# ADA Curb Ramp New Construction Inspection Form (Parallel)

Nw 313

24952.54

Nw commercial

PARALLEL RAMP (PL)

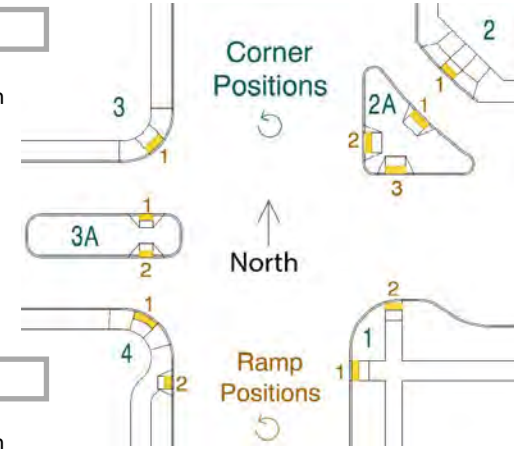
Width X	5.0	$\geq 4.0'$	<input checked="" type="checkbox"/>	$< 4.0'$	<input type="checkbox"/>
Length Y	4.75	$\geq 4.0' * 1$	<input checked="" type="checkbox"/>	$< 4.0' * 1$	<input type="checkbox"/>
Back of Ramp Obstruction (Y/N)		$\geq 5.0' * 1$	<input type="checkbox"/>	$< 5.0' * 1$	<input checked="" type="checkbox"/>
Slope X (Cross Slope 1)		$\leq 2.0\%$	<input type="checkbox"/>	$> 2.0\%$	<input type="checkbox"/>
Slope Y (Running Slope 1)	1.2	$\leq 2.0\%$	<input type="checkbox"/>	$> 2.0\%$	<input type="checkbox"/>

TS less than 5 with obstruction IITD
